SAFETY RECALL

Sr07-10

DATE : FEBRUARY 2008	SECTION : 07
SUBJECT : ZF-ASTRONIC AUTOMATIC TRANSMISSION GEAR SHIFTER PAD DEFECT

FIGURE 1: H3 COACHES

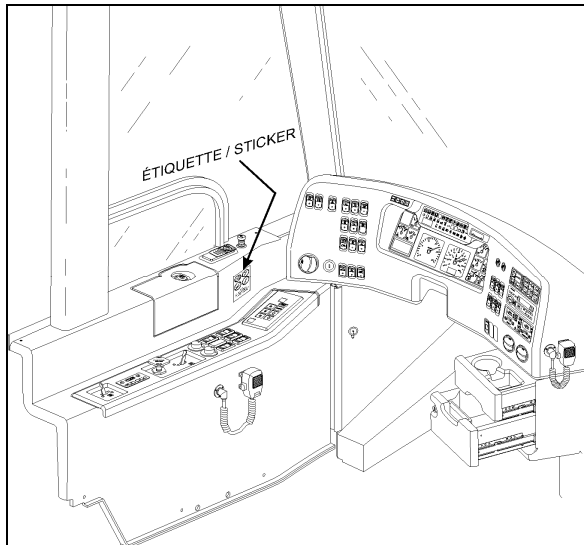
1. Check and confirm that the radio installation is in accordance with the radio supplier's installation guidelines.
2. Affix the sticker (Part #572148) onto the L.H. side of the gear shifter pad as per figures 1 and 2.
